Final Subsequent Environmental Impact Report

Sunshine Canyon Landfill

State Clearinghouse Number 92041053

EXECUTIVE SUMMARY
FINAL SUBSEQUENT ENVIRONMENTAL IMPACT REPORT
SUNSHINE CANYON LANDFILL
SEIR 91-0377-ZC/GPA
State Clearinghouse Number 92041053

FIGURE NO. **5.5-2 (REVISED)**

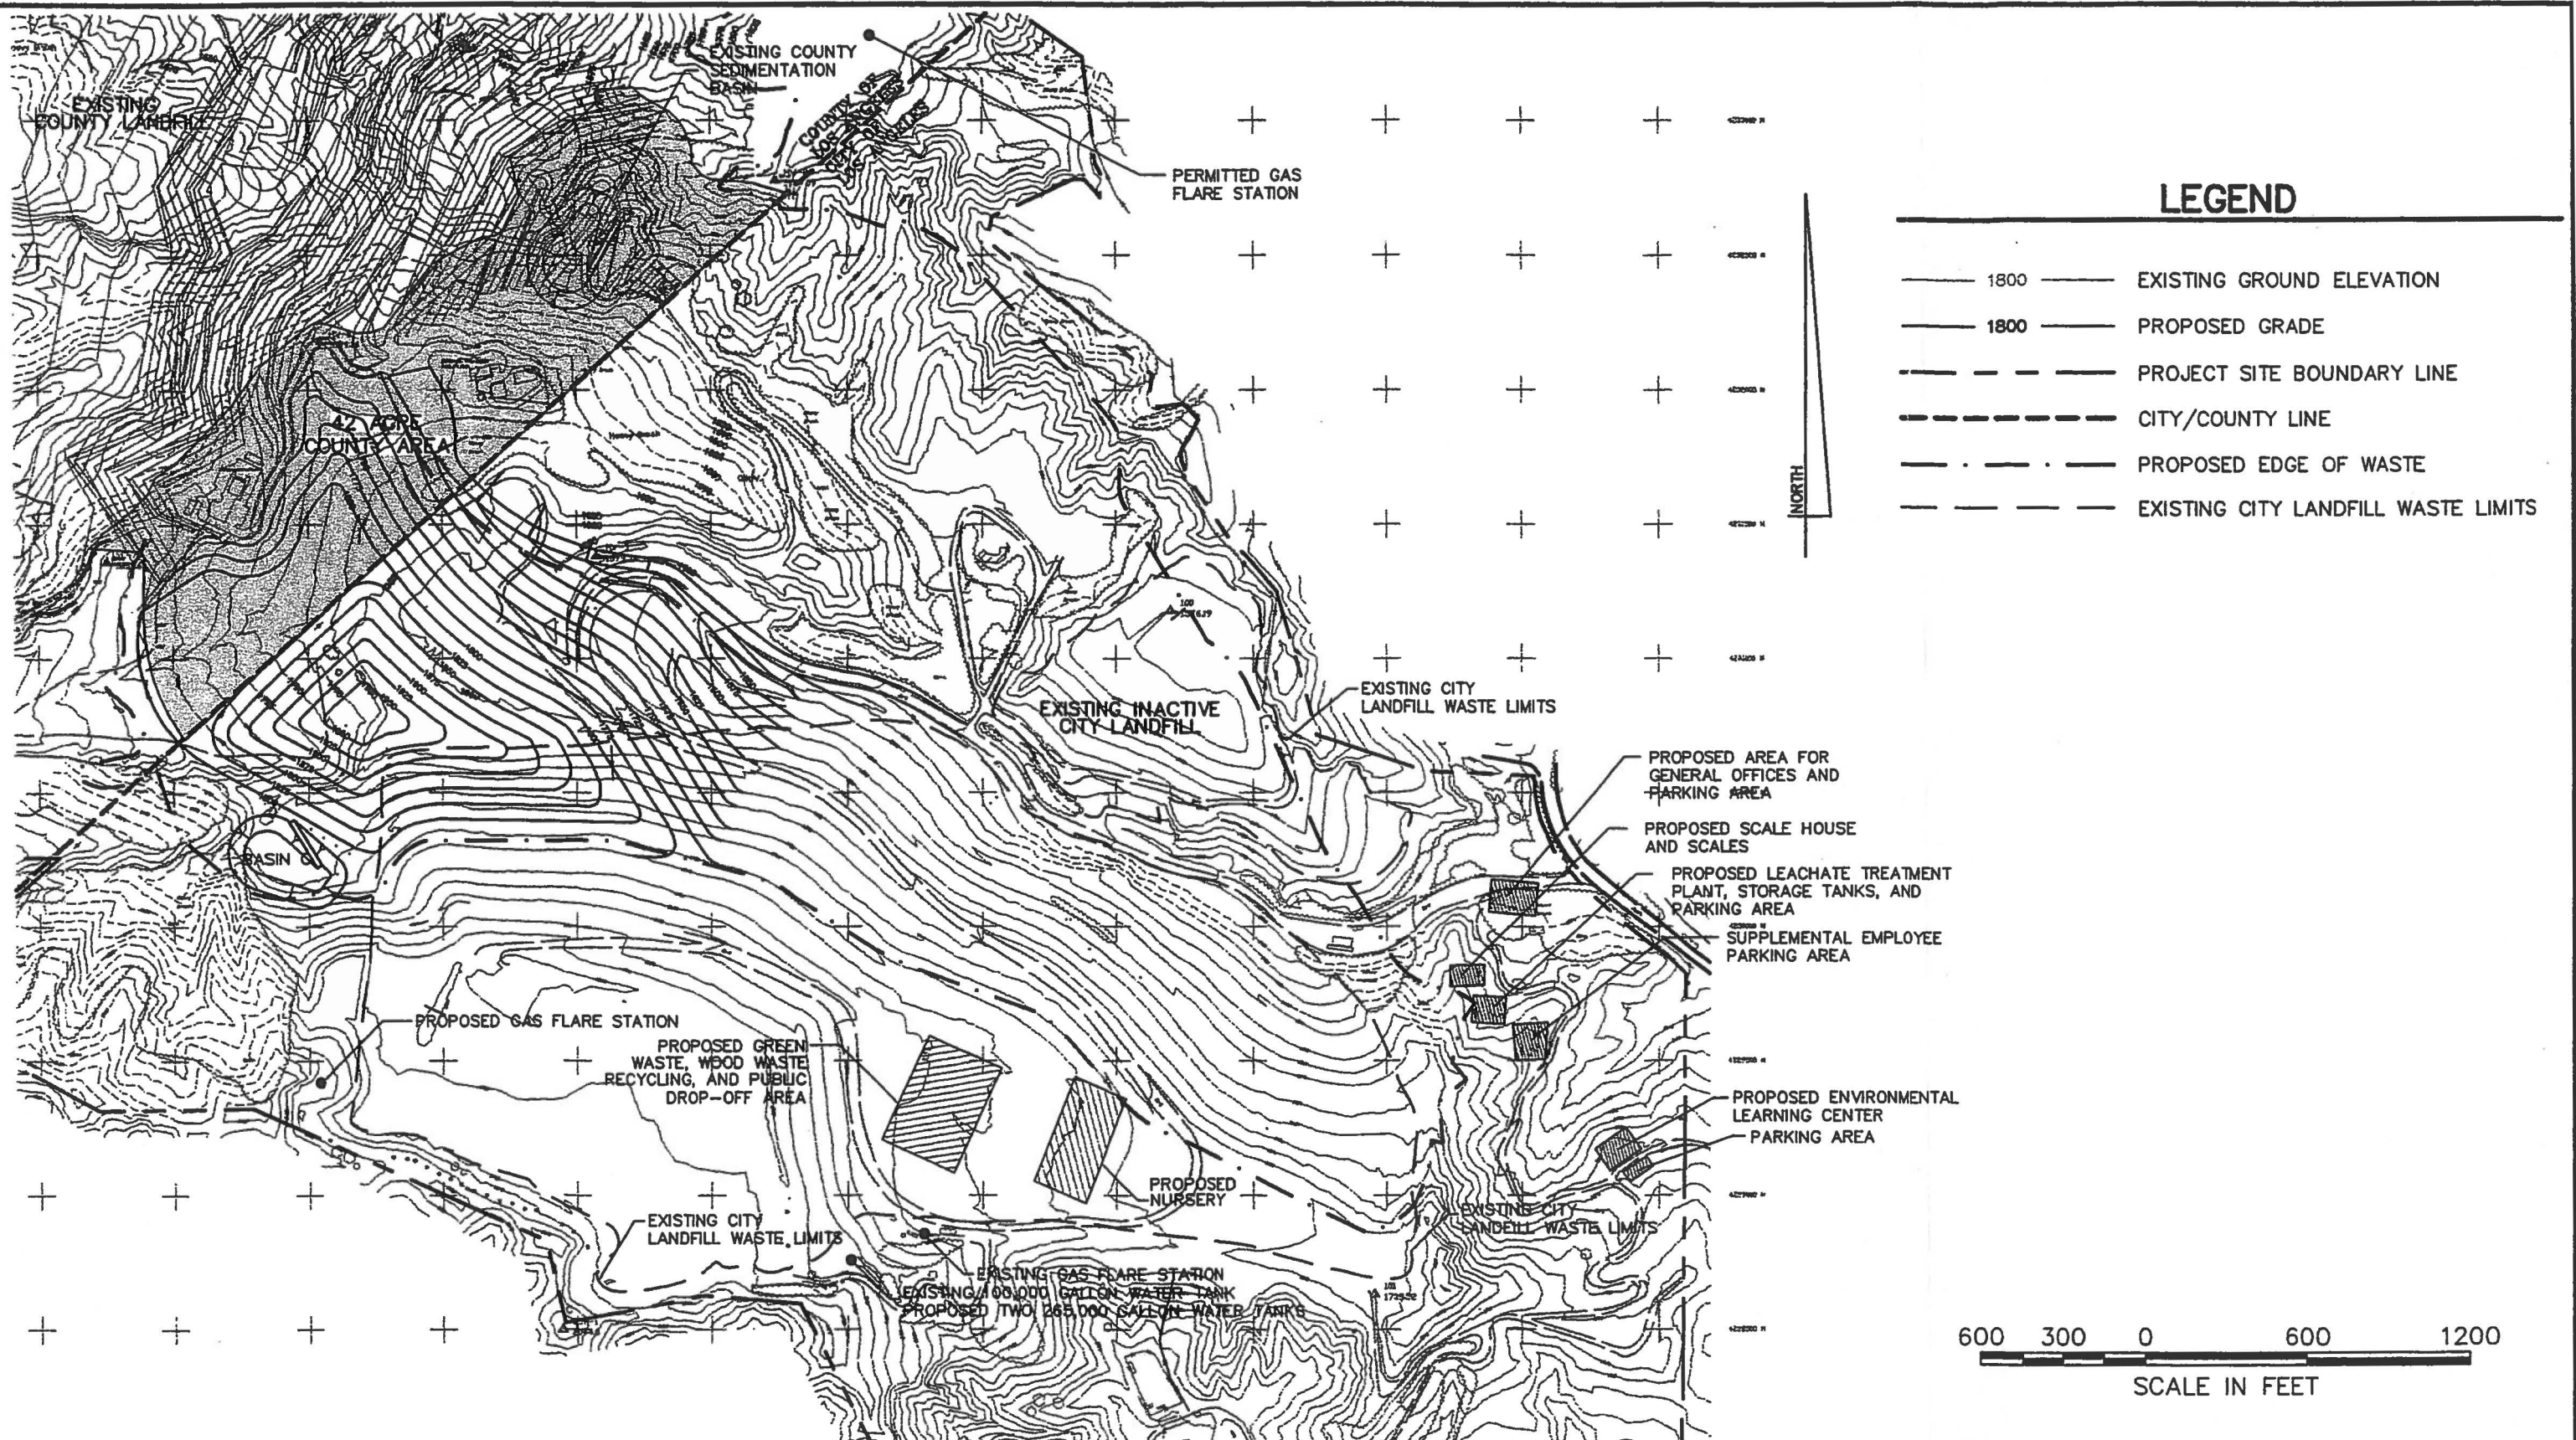
Section 5.5, Reduced Volume Alternative, Figure 5.5-2, p. 15

These changes, made by the project proponent, are not in response to any of the comments included in Section 3.0 of this document.

FIGURE NO. **5.6-1 (REVISED)**

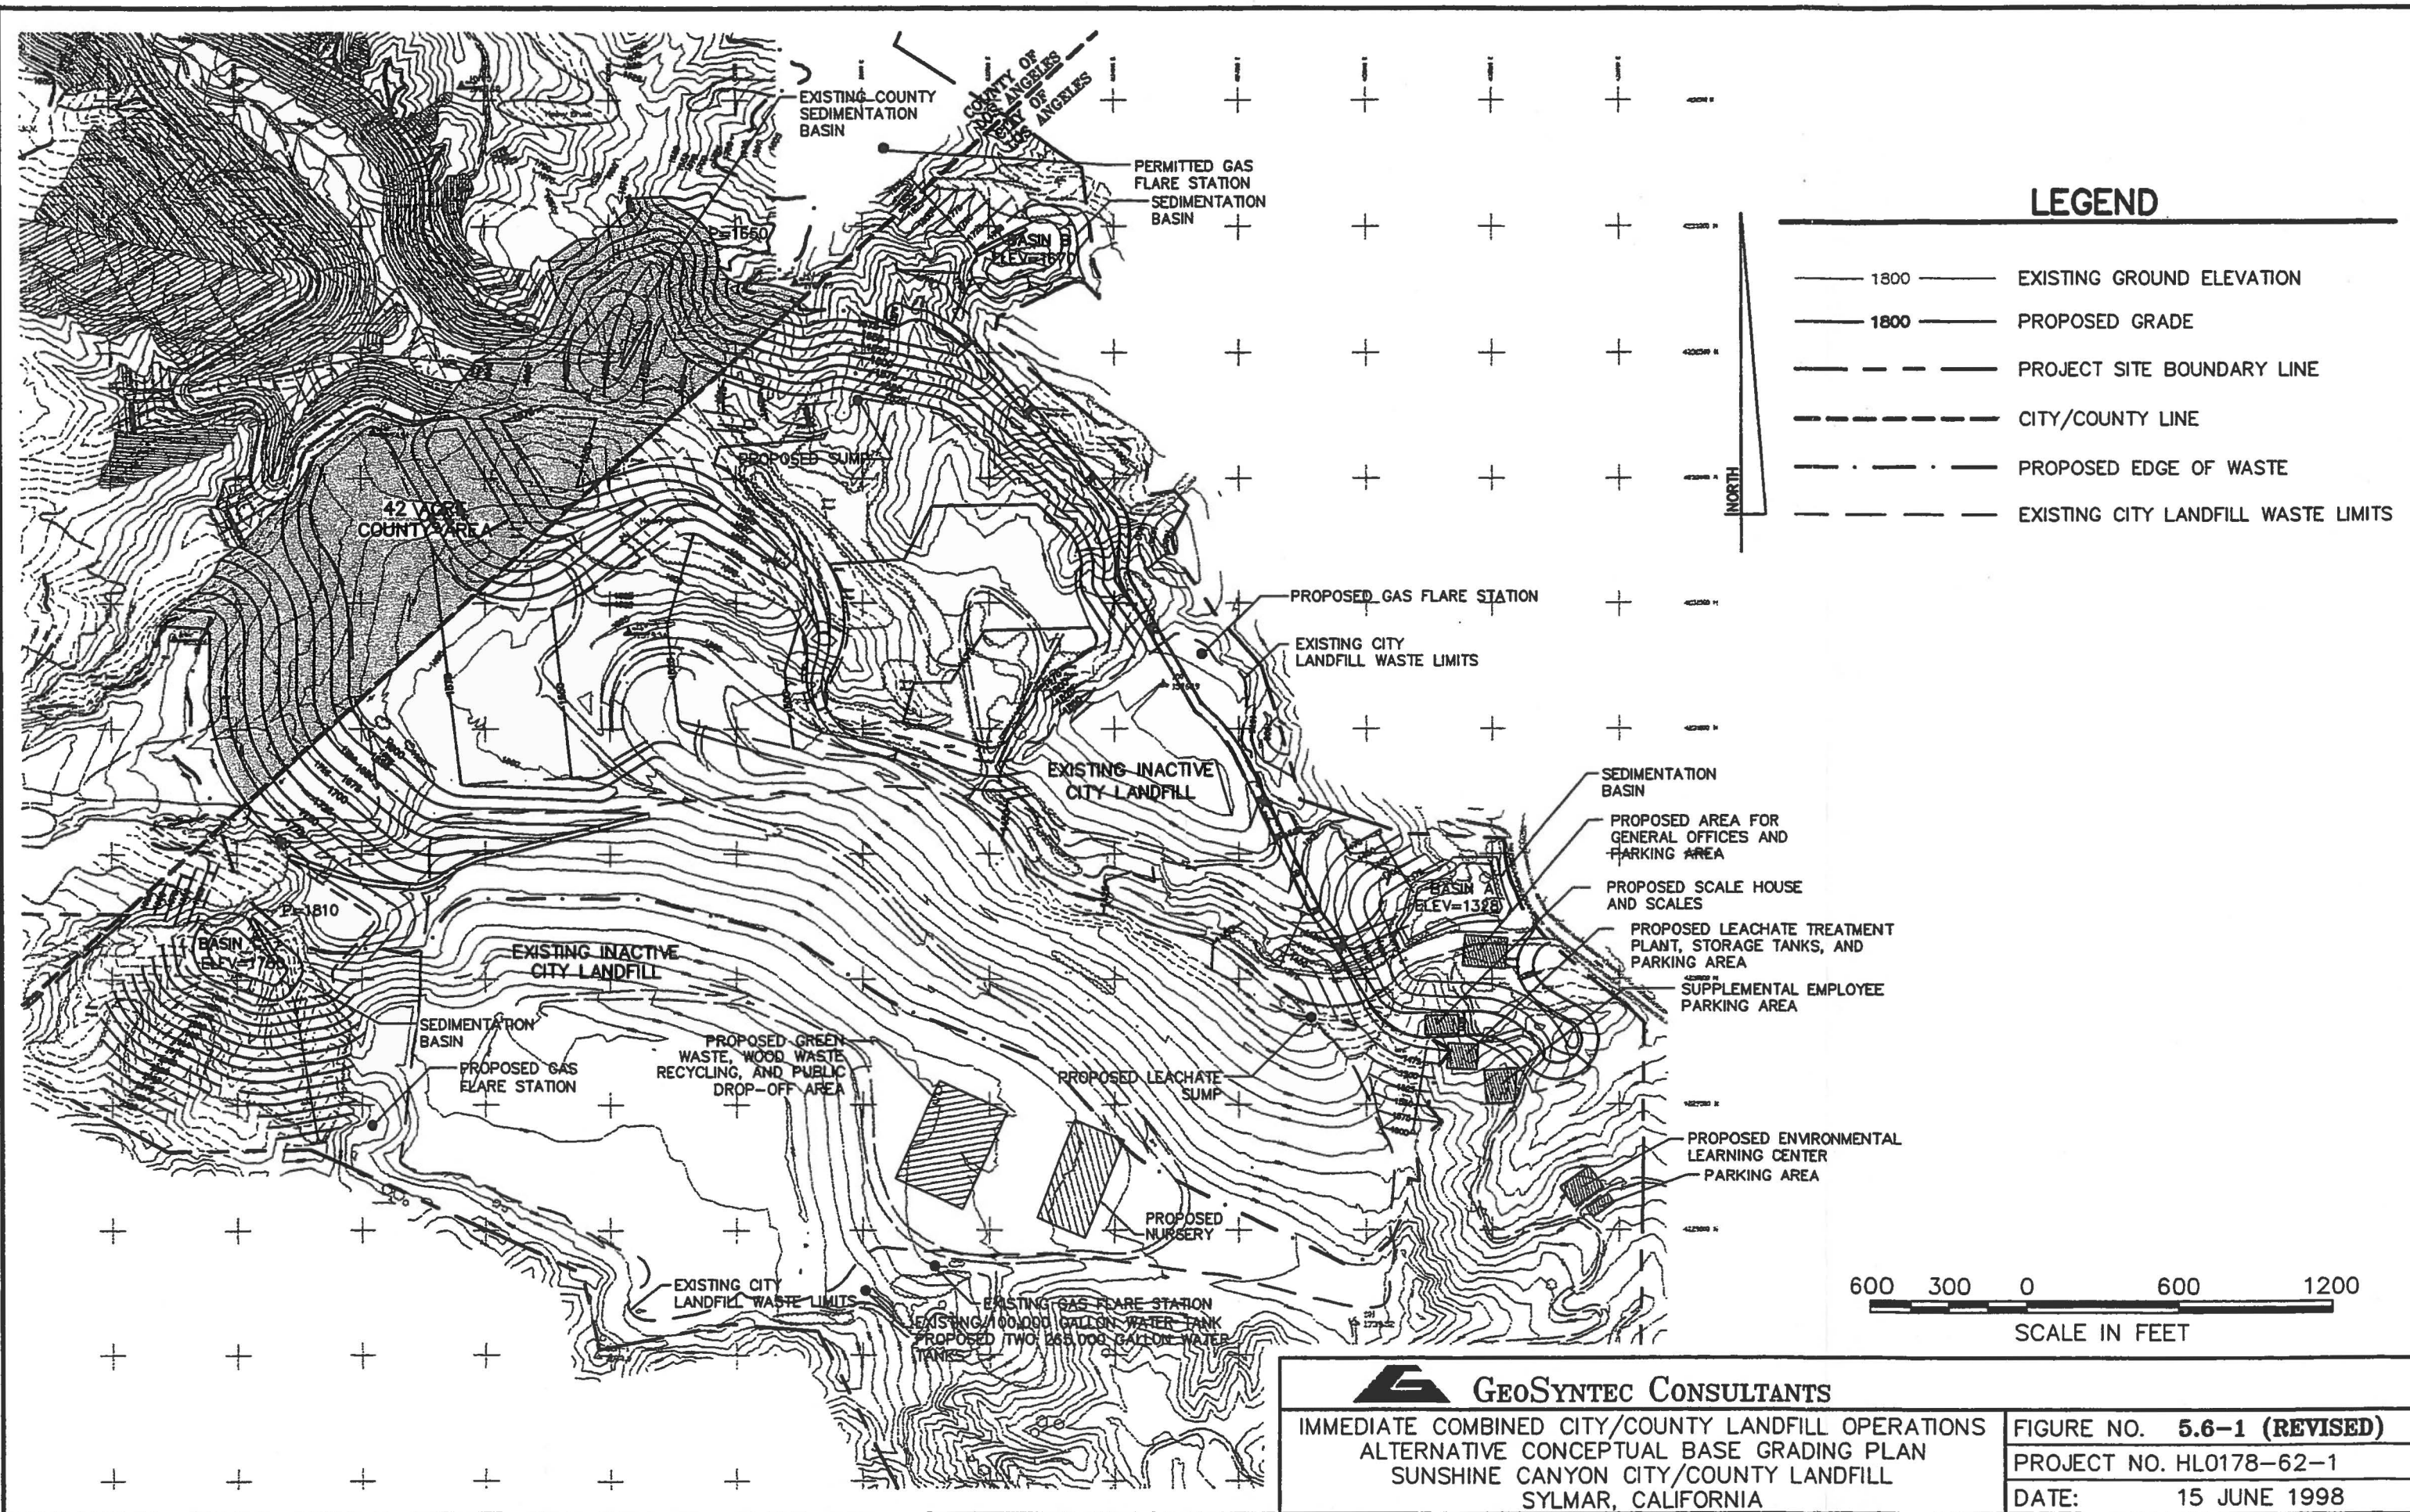
Section 5.6, Immediate Combined City/County Landfill Operations Alternative, Figure 5.6-1, p. 5-19

These changes, made by the project proponent, are not in response to any of the comments included in Section 3.0 of this document.
